HISTORIC AND DESIGN REVIEW COMMISSION

HDRC CASE NO: 2019-578
ADDRESS: 408 DEVINE ST
LEGAL DESCRIPTION: NCB 2958 BLK 2 LOT 51
ZONING: R-5, H
CITY COUNCIL DIST.: 1
DISTRICT: Lavaca Historic District
APPLICANT: Scott Mathis/Kustom Beam
OWNER: Meg Garoutte
TYPE OF WORK: Installation of a carport, reroofing, and gate replacement
APPLICATION RECEIVED: September 16, 2019
60-DAY REVIEW: November 15, 2019
CASE MANAGER: Huy Pham
REQUEST:

408 Devine Street

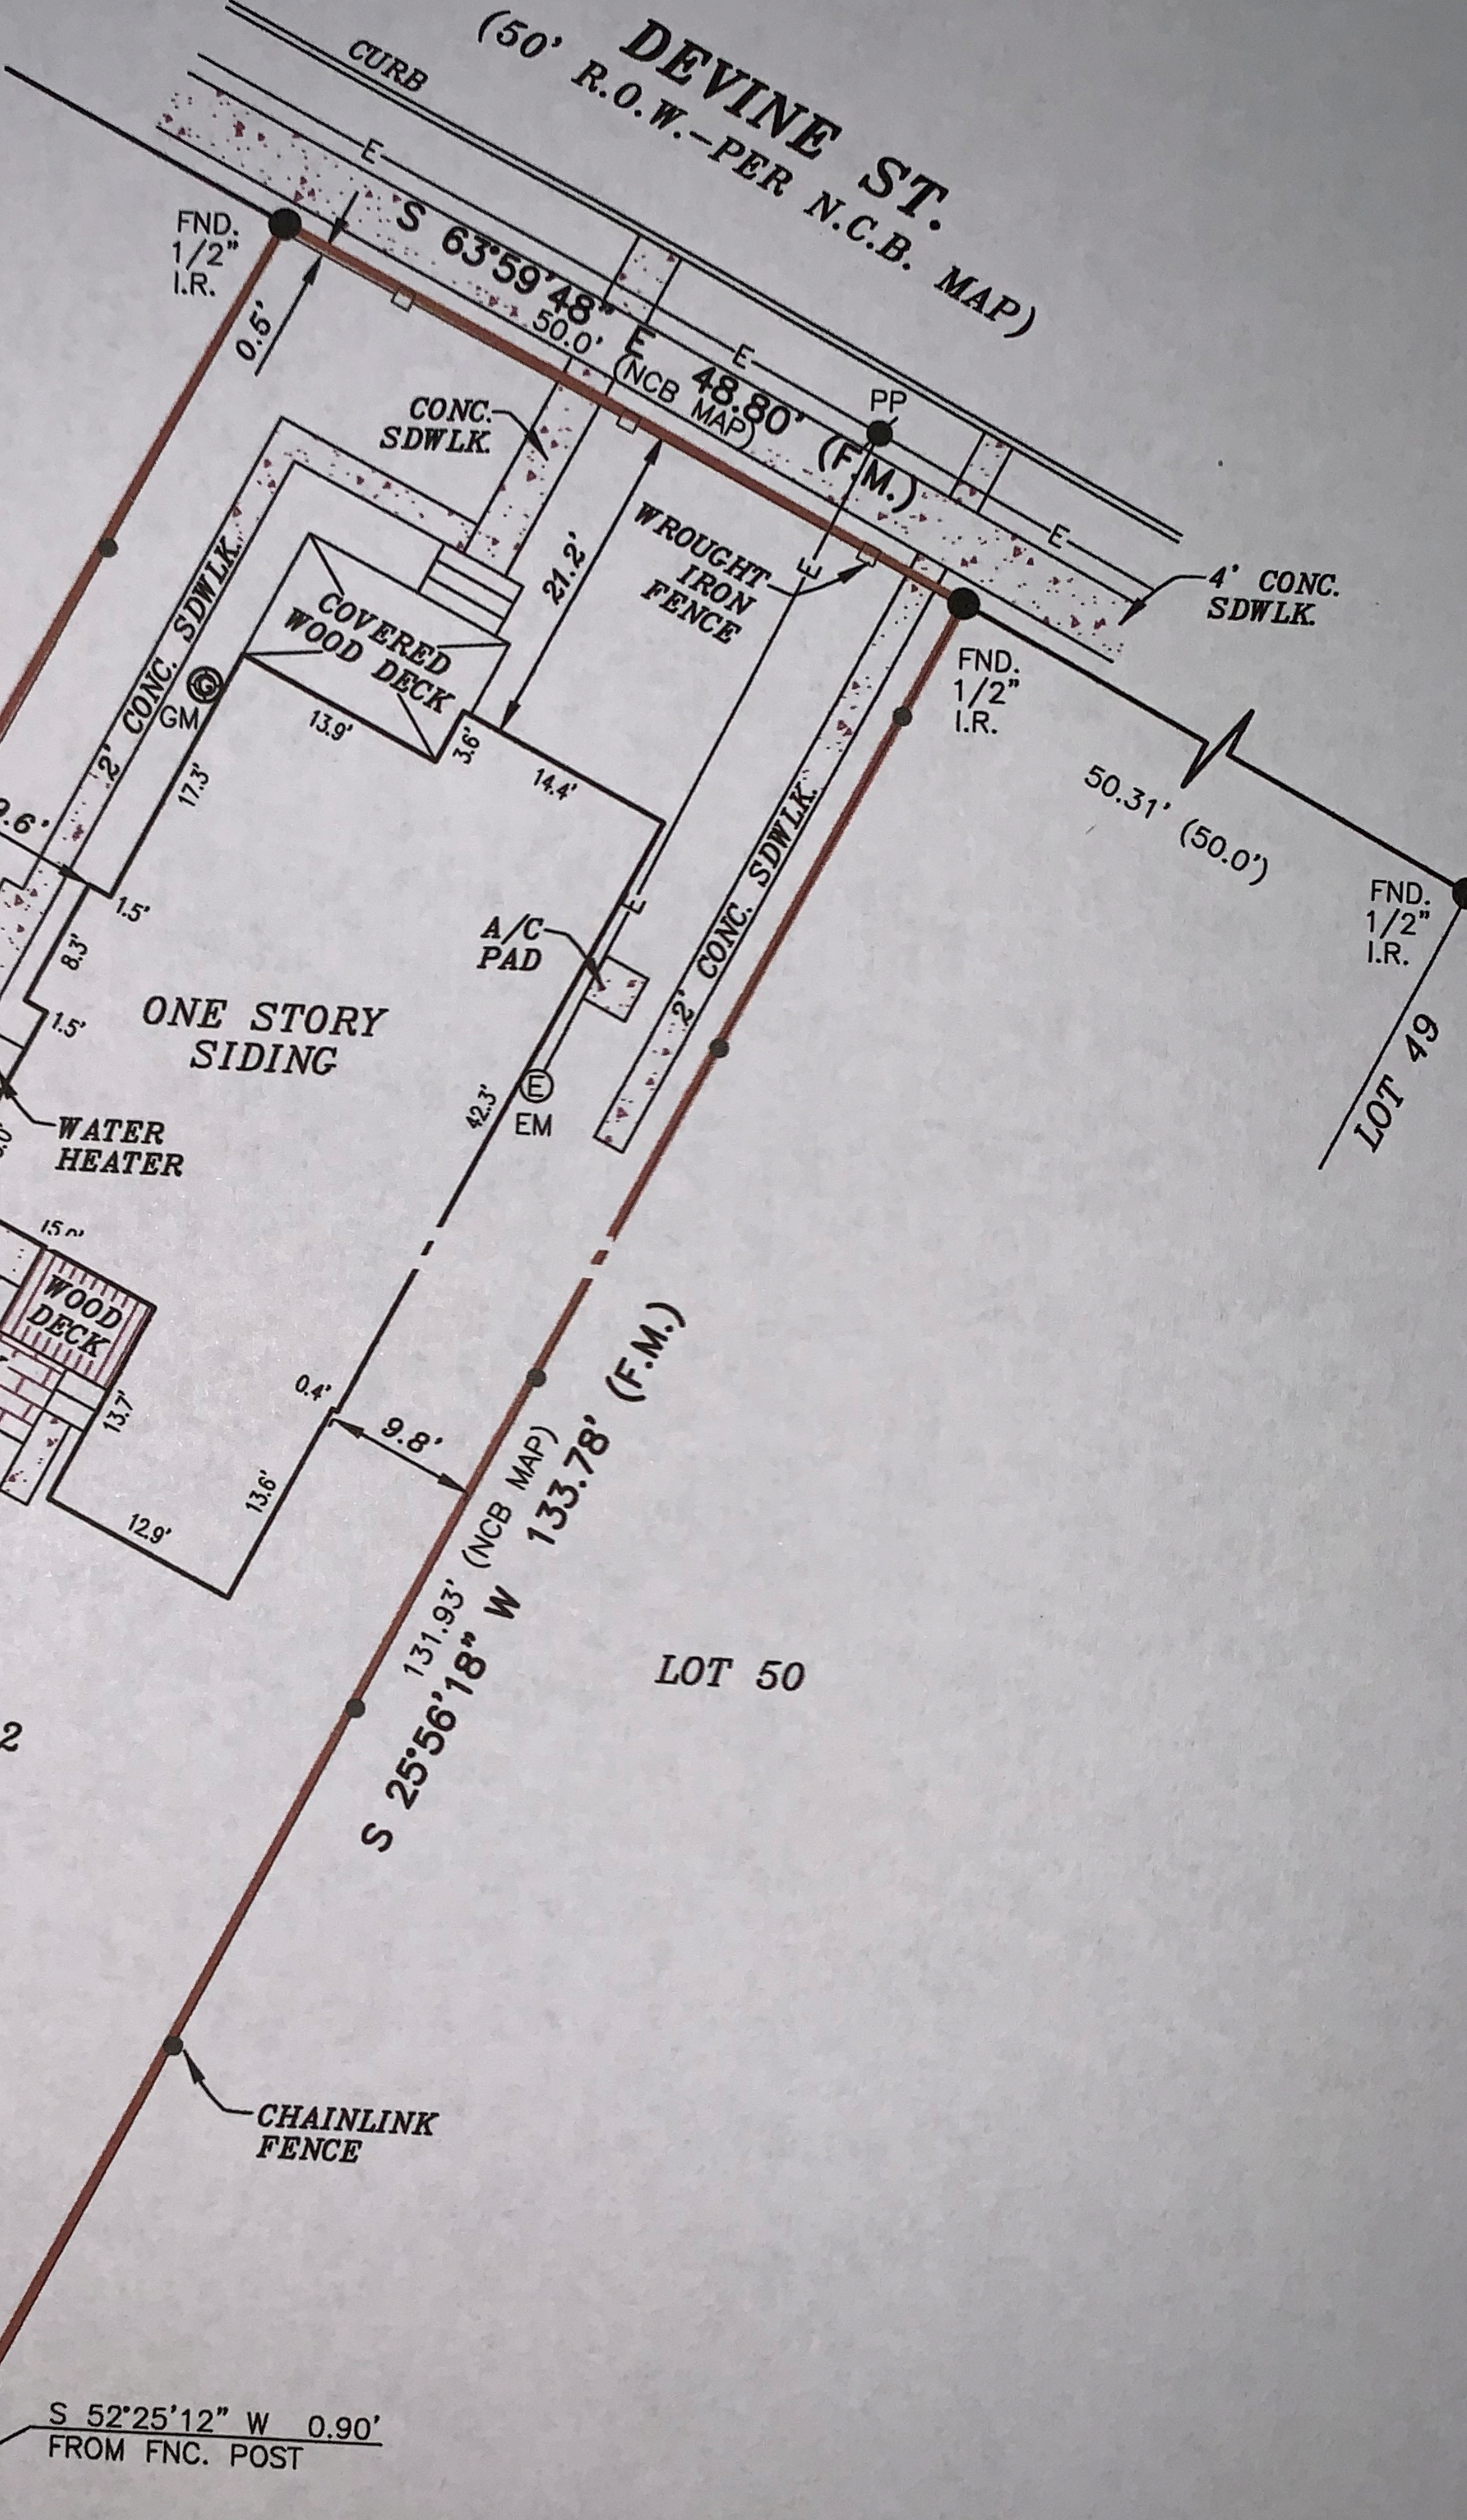
- b. CARPORT – The applicant has proposed to construct a carport measuring 20’ – 8” wide, 19’ – 8” deep, and 14’ – 4” tall in the rear yard with rear alleyway access. The proposed carport is to feature wood framing and a metal roof. The carport will cover a proposed crushed granite parking pad. Staff finds that the simple carport structure is consistent with the Guidelines for New Construction 4.5.A and B in its massing, form, size, character, orientation, and setback in respect to the primary historic structure, neighboring historic structures and rear yards.

- c. REAR GATE – The applicant has proposed to replace the existing wood privacy gate from the rear alley with a metal framed wood fence with interior sliding mechanism. The height of the fence should be limited to the existing fence height, or no taller than 6 feet at any portion. Staff finds that the proposed fence is generally appropriate with the Guidelines for Site Elements 5.2.B.

Staff recommends approval of item 1) carport and 2) rear gate with the following stipulations:

- i. That no portion of the rear gate exceed the height of the existing wood privacy fence or exceed 6 feet in height.
- ii. That no portion of the rear gate’s mechanical equipment be visible from the right-of-way.
- iii. That the applicant comply with all setback requirements as required by Zoning and obtains a variance from the Board of Adjustment, if applicable.
